**ITEM V-B:** DESIGN REVIEW PERMIT AND TENTATIVE SUBDIVISION MAP 8250 INDUSTRIAL AVENUE COASTAL/KMS COMMERCIAL CENTER FILE #2006PL-051 (SUB-000052 & DRP-000101)

### **REQUEST**

The applicant requests approval of a Design Review Permit for the construction of nine (9) light industrial buildings totaling 160,200 square feet and thirteen (13) office buildings totaling 72,900 square feet with associated parking, lighting, and landscaping. The applicant also requests approval of a Tentative Subdivision Map to subdivide two (2) parcels (27 acres and 11 acres) into twenty-three (23) parcels ranging in size from 0.46 acres to 15.19 acres.

Figure 1: Site Plan

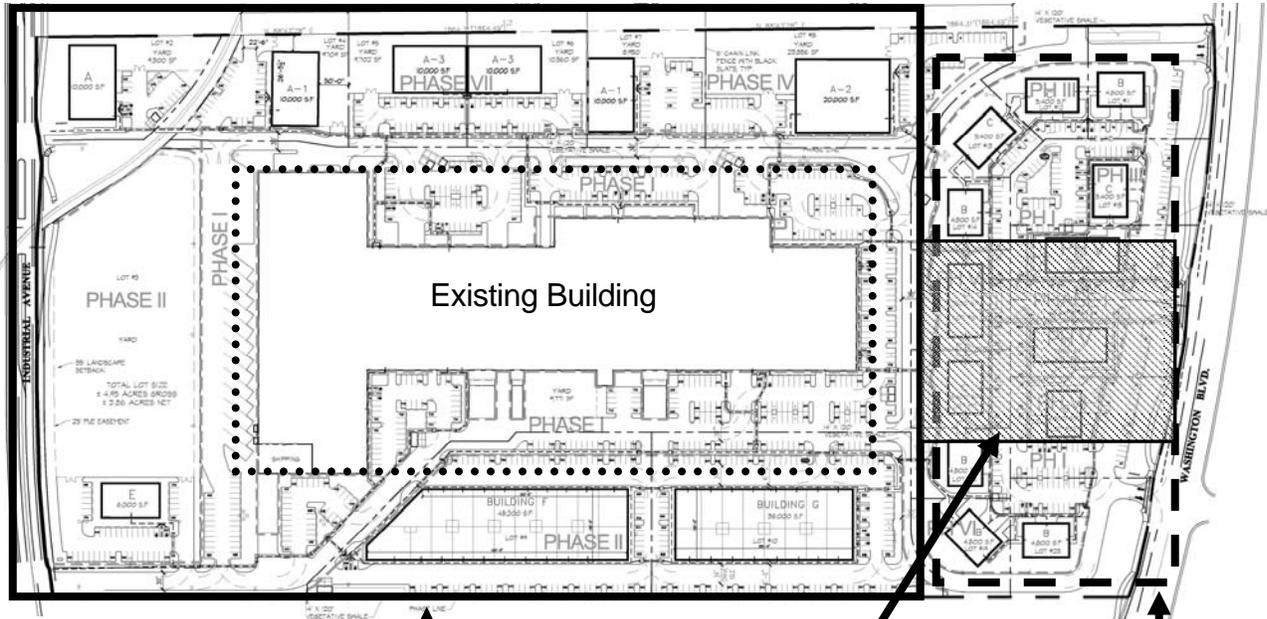
As shown in Figure 1 above, no plaza areas are shown within the industrial portion of the project. Staff has recommended that the applicant include at least two plaza spaces within this section of the project. The applicant has identified two locations, one north of the existing building and one south of the existing building where plaza spaces can be accommodated. These areas will include enhanced paving, shade trees, tables, benches and trash receptacles. The office portion of the development has multiple spaces between each of the buildings available to incorporate plaza space for future employee benefit. Condition #4 has been added to ensure these improvements are constructed as part of the project.

4. At least four plaza areas shall be incorporated into the site plan design that shall include enhanced paving, shade trees, tables, benches and trash receptacles. At least two areas shall be provided for the industrial portion of the project and two for the office portion of the project. The plazas shall be located in central locations to the satisfaction of the Planning Department. (Planning)

Figure 4: 18 Cornice Treatment

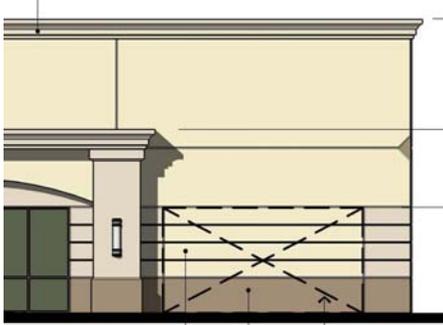
- Also related to massing, the parapet and canopy components include an eighteen inch thick cornice treatment. Staff believes that a larger cornice element may be appropriate for the industrial buildings and will be more proportional to the massing and height of the buildings. Condition #10 requires the cornice to be increased in height to between twenty-eight and thirty inches.

10. The cornice treatment as shown in Exhibits D-K shall be increased in height to a minimum of twenty-eight inches. (Planning)
11. Parking lot light fixtures shall not exceed twenty-five feet in height for the office component of the project. Parking lot fixtures within the industrial component of the project shall not exceed thirty-five feet in height. (Planning)
